Item Name: Replacement Skidtube, Low Gear with Run-on Landing Fits LH or RH

DART AEROSPACE USA, INC PORT HADLOCK, WA	
DRAWING NO. D3804	REV. A SHEET 1 OF 5
TITLE SKIDTUBE ASSEMBLY, 206A/B	SCALE NTS
COPYRIGHT © 2008 BY DART AEROSPACE USA, INC. THIS DOCUMENT IS PRIVATE AND CONFIDENTIAL AND IS SUPPLIED ON THE EXPRESS CONDITION THAT IT IS NOT TO BE USED FOR ANY PURPOSE OR COPIED OR COMMUNICATED TO ANY OTHER PERSON WITHOUT WRITTEN PERMISSION FROM DART AEROSPACE USA, INC.

DRAWING NO. D3804	TITLE SKIDTUBE ASSEMBLIES, 206A/B	REV. A	DART AEROSPACE LTD ENGINEERING ORDER		D.E.O. NO. D3804-A-1	SHEET NO. SHEET 1 OF 1	SCALE NTS
DRAWN OP	CHECKED A.P.	MFG. APPR.	APPROVED		DE APPR.		
DATE 12.10.12	DATE 12.10.22	DATE 12.10.22	DATE 12.10.22		DATE 12.10.22

CHANGE C'BORED WELDED CROSSBOLT SPACERS TO SWAGED SPACERS

AMENDMENT TO DETAIL B
NOT TO SCALE

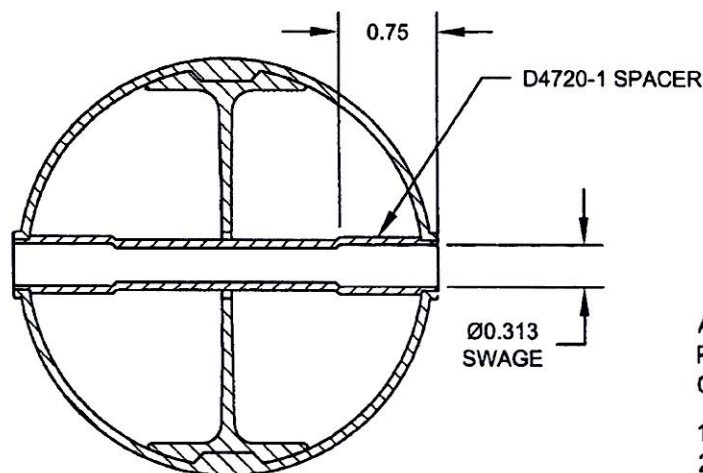
ADD SECTION H-H BELOW, WHICH IS THE SAME SECTION VIEW AS SECTION D-D OF DWG.
C'BORED HOLES ARE **NOW SWAGED** PER SECTION H-H BELOW. FOR THE Ø0.375 HOLE THAT IS NOT C'BORED, WELD PER SECTION D-D OF DWG (SEE AMENDED DETAIL B FOR REFERENCE).
